Architectural Review Board Staff Report

Project Type:	Site Development Section Plan
Meeting Date:	November 08, 2018
From:	Mike Knight, Planner
Location:	A 7.3 acre tract of land located northeast of the intersection of Wild Horse Creek Road and Old Chesterfield Road.
Description:	<u>Downtown Chesterfield Category C, Lot A (The Pearl at Wild Horse Creek)</u> SDSP: A Site Development Section Plan, Landscape Plan, Lighting Plan, Architectural Elevations and Architect's Statement of Design for a 7.3 acre tract of land located northeast of the intersection of Wild Horse Creek Road and Old Chesterfield Road.

Staff requests review and recommendation on this submittal for Downtown Chesterfield Category C, Lot A (The Pearl at Wild Horse Creek) Site Development Section Plan.

**Re: The Pearl at Wild Horse Creek
TR,i Project #: 18-030
ARCHITECT'S STATEMENT OF DESIGN**

Figure 3: Color Site Plan

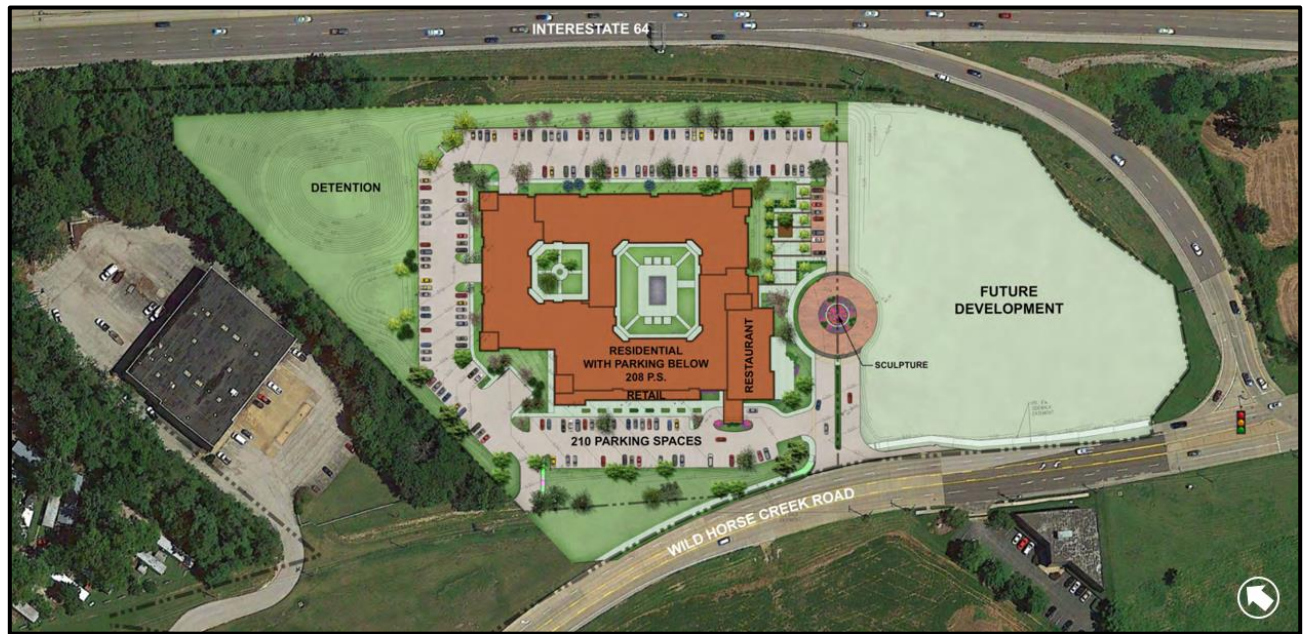
Below in Figure 3 is a color Site Development Section Plan for the proposed development. Although the applicant plans on future development shown to the east of the site, this review is solely for the western half of the roadway that enters the site from the south. Staff does point out that the architect’s statement of design submitted references a hotel on the future development to the east and a fountain feature that is not seen in this submittal. It is our understanding that the water feature has been removed and the hotel is still planned for future development but is not shown as it will be reviewed by the Board upon submittal of a separate Site Development Section Plan.

Pedestrian circulation can be seen completely circumnavigating the building, but it is unclear whether the primary pedestrian connection points to the developments to the east, west, and south. The City of Chesterfield Bikeable-Walkable plan designates a planned bike lane along this section of WHCR. The submittal currently does not show a bike lane along the major arterial.

Figure 5: Lighting

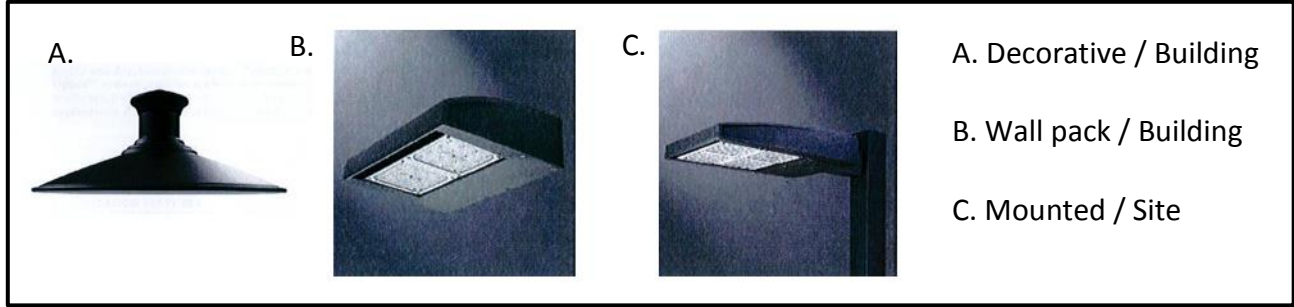
Lighting consists of utilitarian and decorative fixtures and is still under review within the Site Development Section Plan review process. There are three (3) fixtures in which two (2) are utilitarian and one (1) is decorative. Below in Figure 5 are examples of all three fixtures. All the lighting proposed is flat lensed and fully shielded.

Figure 7: Exhibit 1 from Governing Ordinance

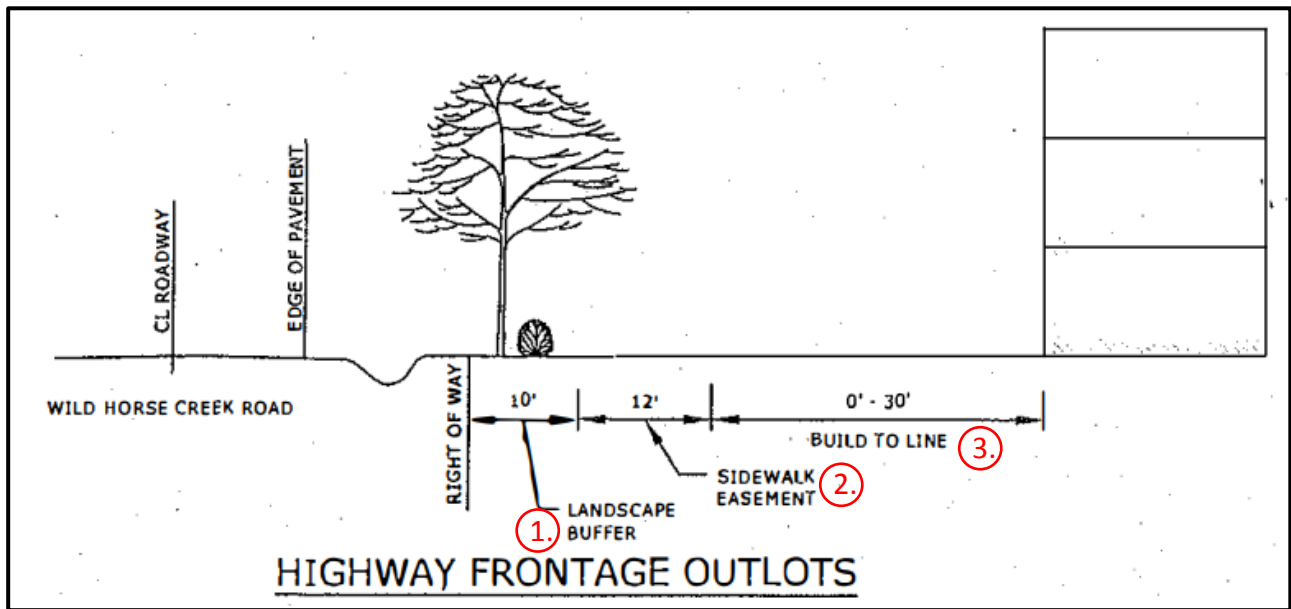
1. Current plan states a 30' landscape buffer along WHCR; Exhibit 1 has a maximum of 10'.
2. A 12' sidewalk easement is required in Exhibit A and not shown on the plan
3. The maximum distance a building can be from the WHCR right of way is 52' according to Exhibit A. The minimum distance of a building from WHCR is no less than 100' represented on the current submittal.
4. Exhibit A specifically removes parking in between WHCR and the "build to" line unlike Categories A & B. This submittal has 2 rows of parking between WHCR and the development on Lots A and B.

Staff acknowledges and is supportive of the center drive aisle dictating an urban "Downtown" streetscape vs. the major arterial of WHCR. Staff encourages more interaction with the street and the building's urban form as dictated in the streetscape identified in Exhibit 1 of the governing

ordinance. As proposed the parking along the center drive aisle and the expansive green areas in between the aisle and building deviates from the downtown essence that exists within the streetscape.

The applicant has provided a modification request stating the intent of the request is to achieve the goals and objectives of the PC&R district. This site focuses on the center of the proposed development with a plaza, roundabout, public art, sidewalks and park benches. The proposed buildings will surround the plaza and bring a "Downtown" feel to the area and further the intent of the PC&R. The applicant will essentially be building the streetscape off of the internal drive vs. WHCR.

EXHIBIT 1

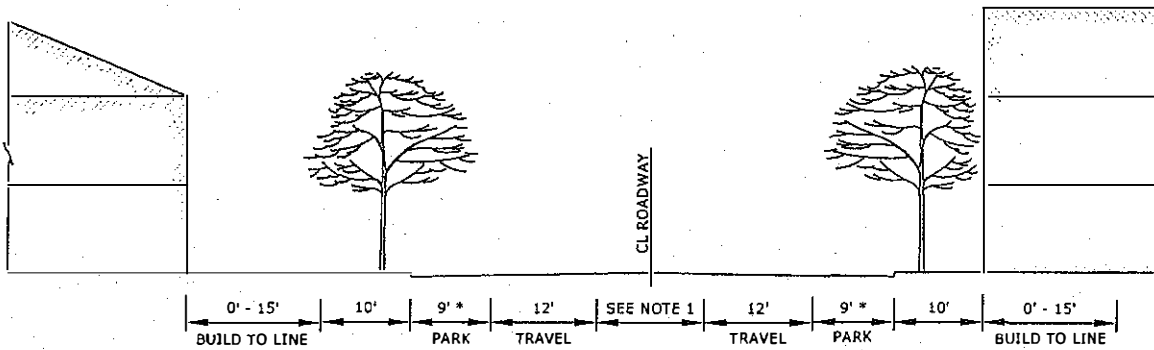
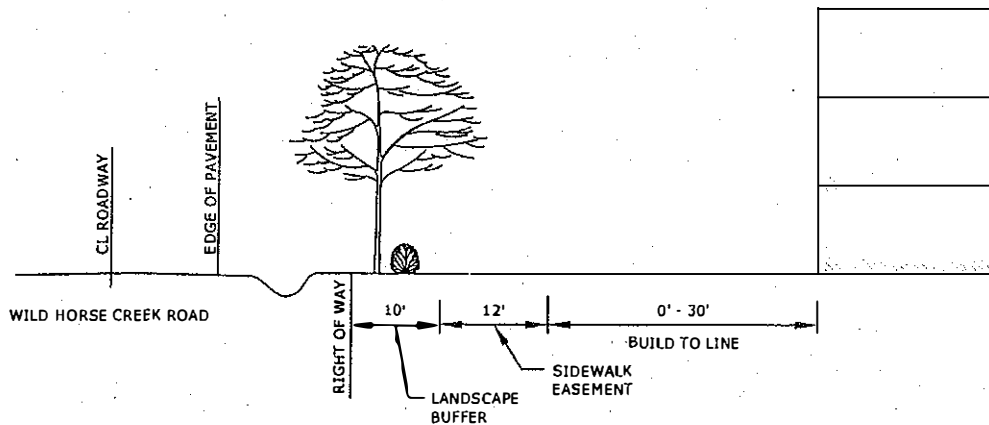
Comment 28. The governing ordinance has specific design guidelines for Category C. Below are conflicts found within Exhibit 1 of the governing ordinance and the SDSP submitted. Amend plan to conform or if the applicant wishes to deviate from this exhibit, please follow steps outlined in Comment #7 of this letter.

- A. Current plan states a 30’ landscape buffer along WHCR, Exhibit 1 has a maximum of 10’.*
- B. Depict the 12’ sidewalk easement required in Exhibit 1.*
- C. The maximum distance a building can be from the WHCR right of way is 52’ according to Exhibit 1. The minimum distance of a building from WHCR is no less than 100’ represented on the current submittal.*
- D. Exhibit 1 specifically removes parking between WHCR and the “build to” line unlike Categories A & B. This submittal has 2 rows of parking between WHCR and the developments on Lots A & B. Adjust accordingly.*

Pursuant to your Site Development Section Plan Comment letter dated September 26, 2018, in particular “General Comments” 7 & “Site Development Section Plan (SDSP)” comment 28 “A-D.” we respectfully request your consideration to modify Exhibit 1 of City of Chesterfield Ordinance 2449 to create Design Standards for Category C - “Highway Frontage Outlots” (Portions of District north of relocated Wildhorse Creek Road).
